REQUEST FOR ADDITIONAL INFORMATION
US-APWR Topical Report: Non-LOCA Methodology, MUAP-07010-P(R1)

4/08/11
Mitsubishi Heavy Industries
Docket No. 52-021
SRSB Branch

The following Requests for Additional Information (RAIs) are follow-up RAIs to the Rod Ejection Accident Analysis RAIs transmitted to MHI on December 6, 2010, and responded to by MHI on January 14, 2011. This RAI will be referenced as the eleventh set of RAIs for this Topical Report.

Figure REA-12.1: Potential Ex-Core Detector Failure Scenario

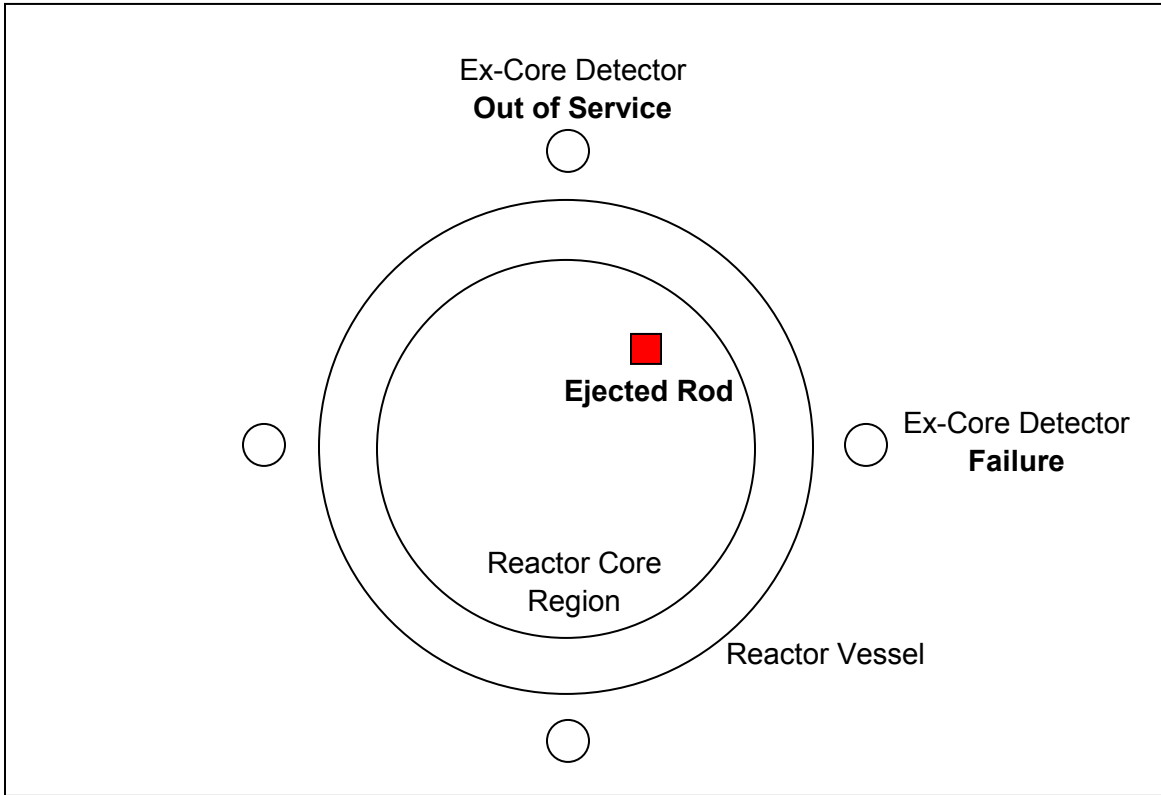
REA-12: This is a new RAI. The nominal value for the power range high neutron flux setpoint is 109% (as documented in Chapter 7 of the US-APWR DCD). The value for this protective system setpoint used in the safety analysis is 118%. Demonstrate that this additional 9% conservatism is sufficient to bound all rod ejection accident scenarios. As an example, consider the case where one excore detector is out of service, another excore detector fails to operate, and the ejected rod is located at the periphery of the core between the two failed detectors. See Figure REA-12.1 for an illustration.
